**PARALLEL CURB RAMP**  
**STANDARD PLAN F-40.12-03**

# SUPPLEMENTAL TO STANDARD PLANS

## F-40.12-03, F40.14-03, F40.15-04, F40.16-03

### **Modify the Standard Plan as follows:**

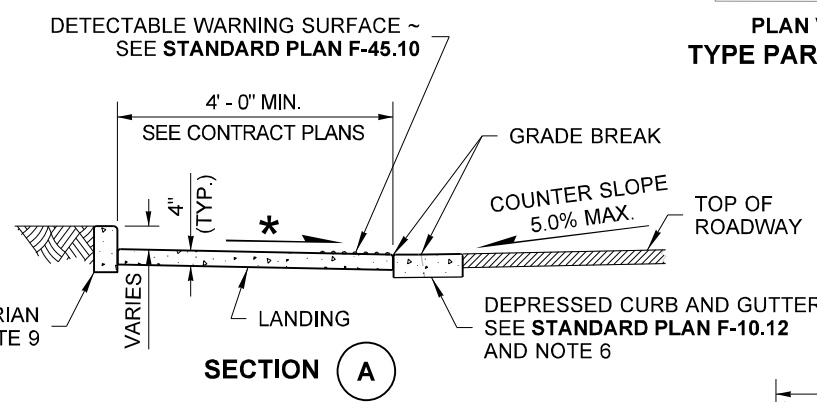
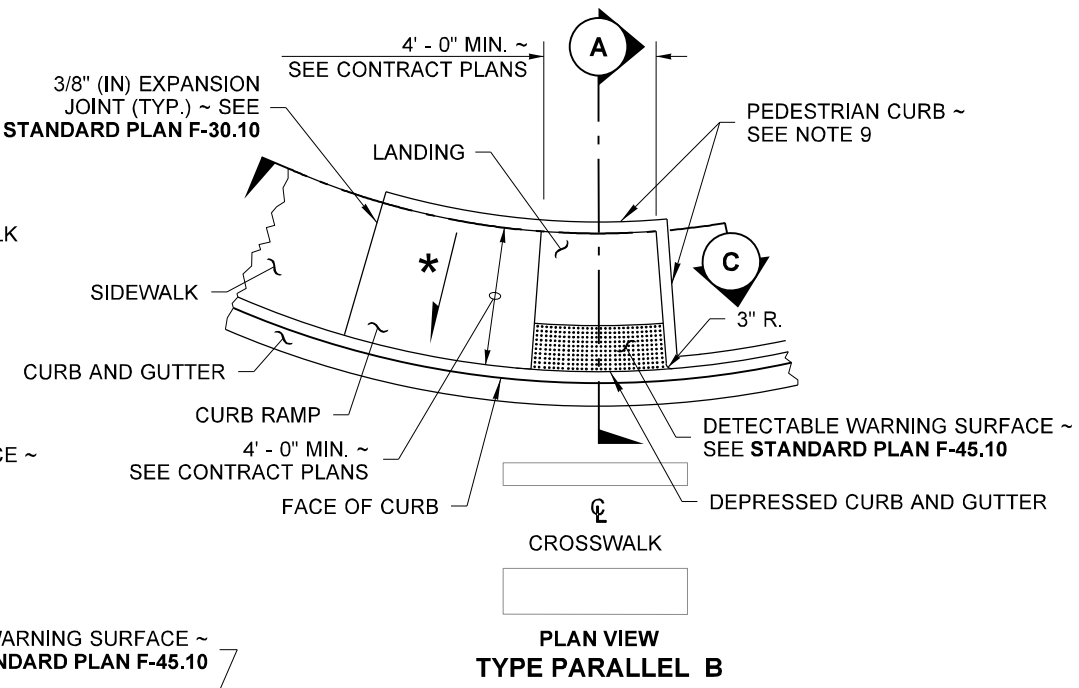
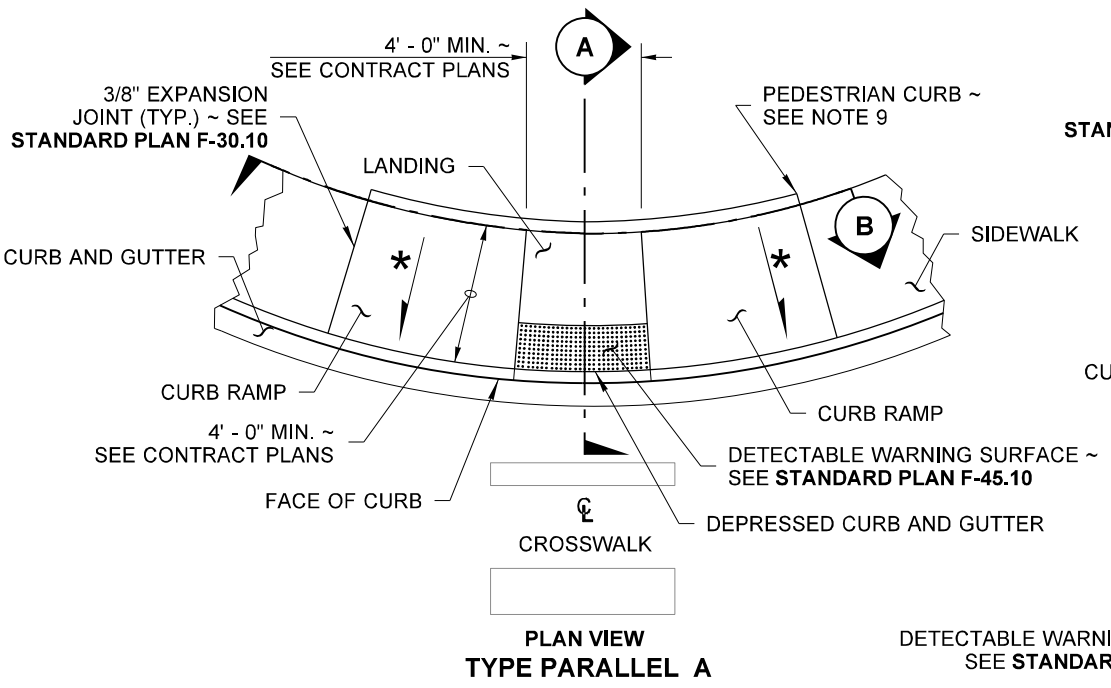
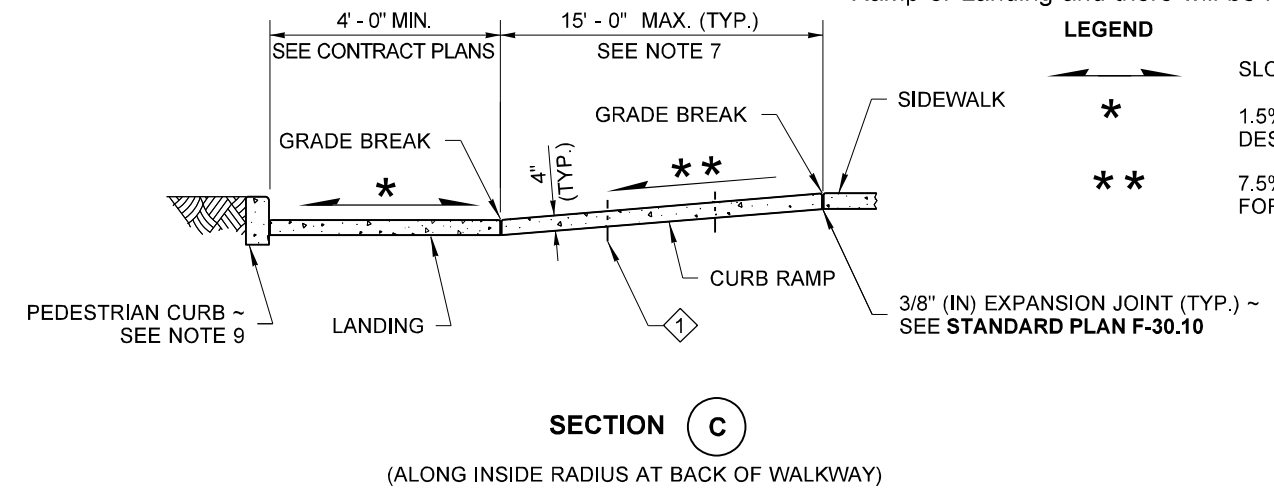
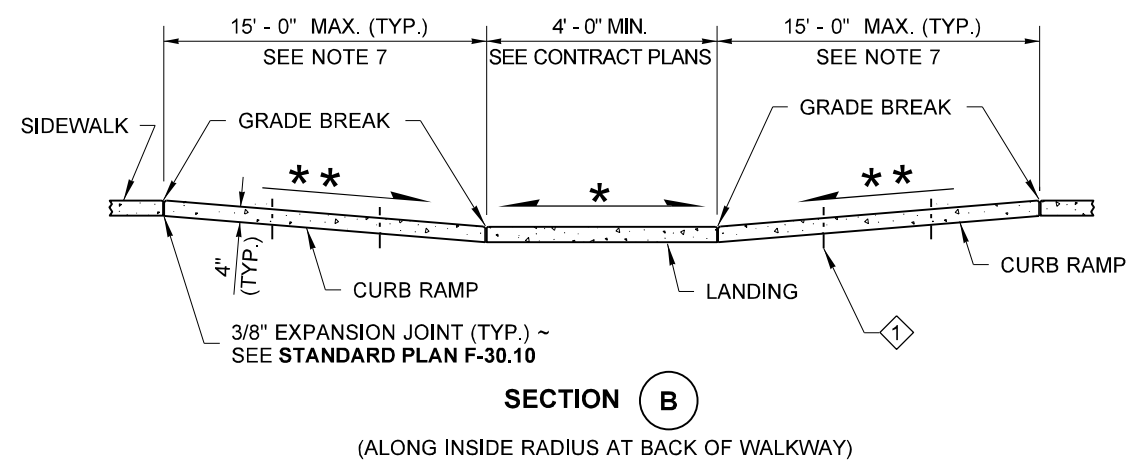
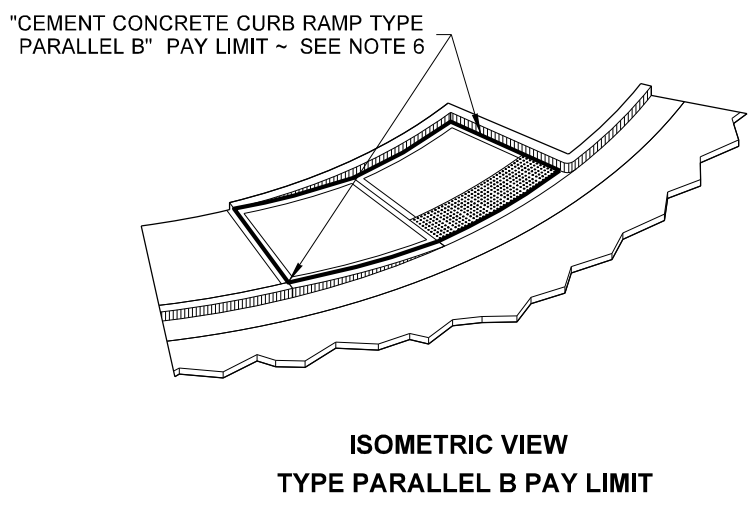
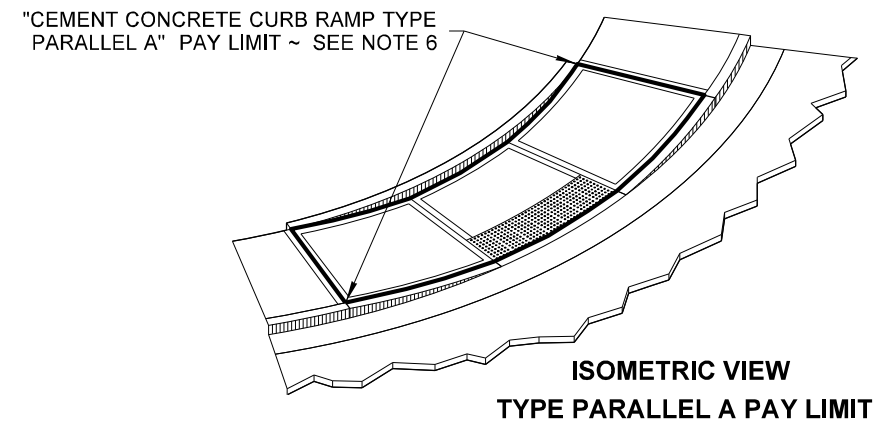
1. Construct a 4" thick layer of compacted CSTC under all concrete.
2. Delete reference to expansion joints in the Standard Plan. Where expansion joints are shown on the Standard Plan construct a contraction joint, except where the new concrete abuts existing construct a construction joint.
3. A raised edge per WSDOT Standard Plan F-30.10-03 may be constructed instead of pedestrian curb.
4. The depressed curb and gutter abutting the width of the curb ramp shall have 0" height.
5. Pay limits for curb ramps are modified to include the pedestrian curb/raised edge, where shown in the plans. The measurement of the area of pedestrian curb/raised edge included in the pay limits will be limited to the surface area of the top of the pedestrian curb/raised edge. Modify note 6 to delete "Pedestrian Curb".
